SERVICE BULLETIN

NUMBER: SB 500-28-001
MODEL: Eclipse EA500
SUBJECT: Fuel Gauging Probes Replacement

Figure 1. Fuel Gauge With Proper Inspection Stamp

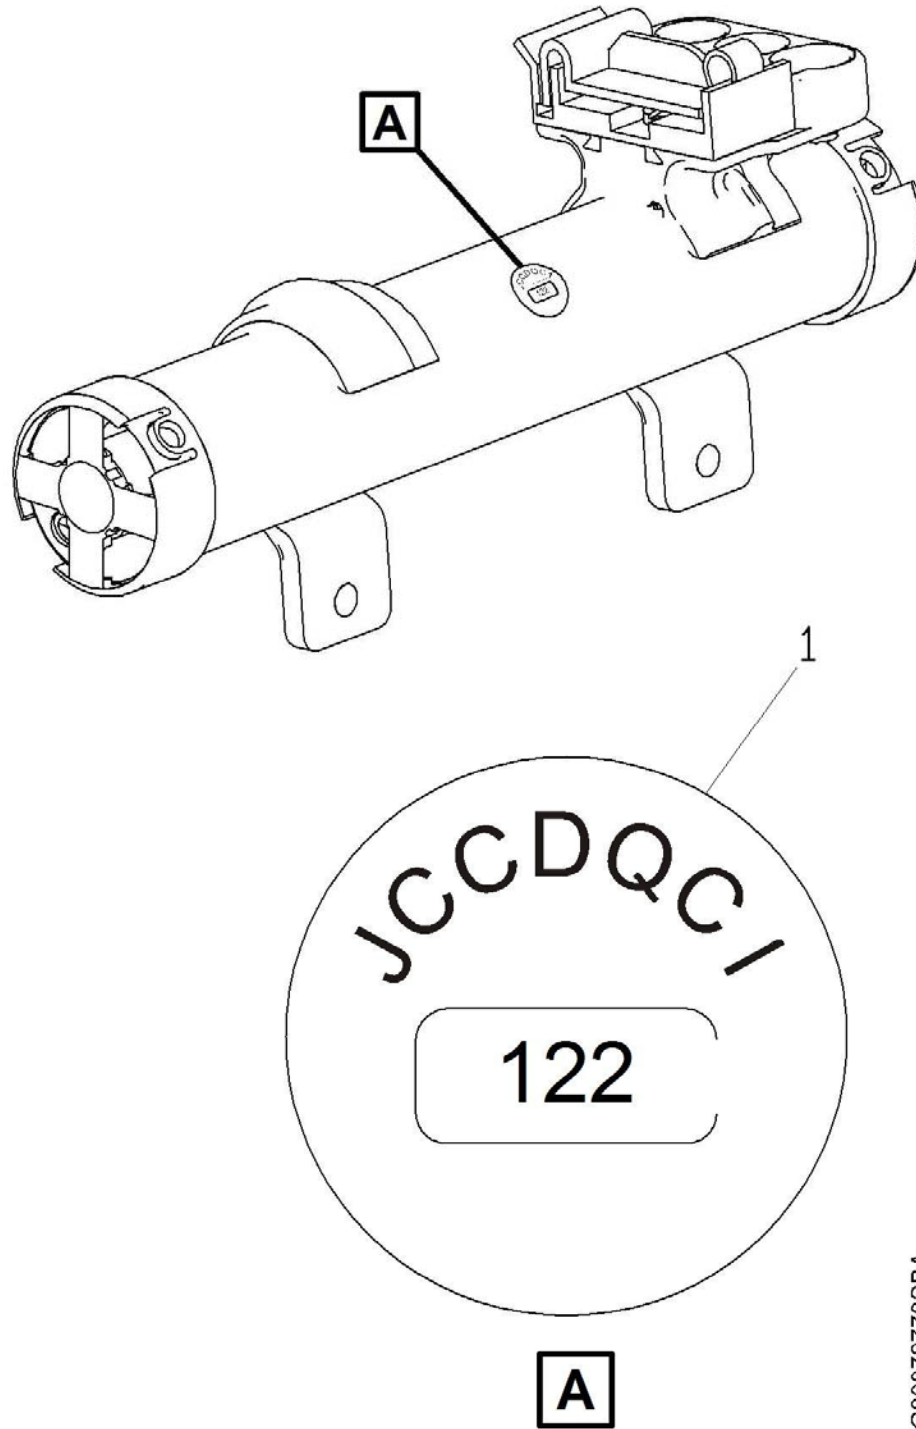
WARNING: ENSURE FUEL GAUGING PROBES TO BE INSTALLED ARE MARKED WITH PROPER INSPECTION STAMP (1, FIGURE 1). FAILURE TO INSTALL CORRECT PROBE MAY RESULT IN ERRONEOUS FUEL QUANTITY INDICATIONS.

- (10) Install new fuel gauging probes P/N 62257-1, 62257-2, 62257-3, 62257-4, 62257-5, 62257-6, 62257-7 with the proper inspection stamp (1, Figure 1). Refer to AMM 28-40-10-041-A-921-001 and AMM 28-40-10-041-A-411-001.
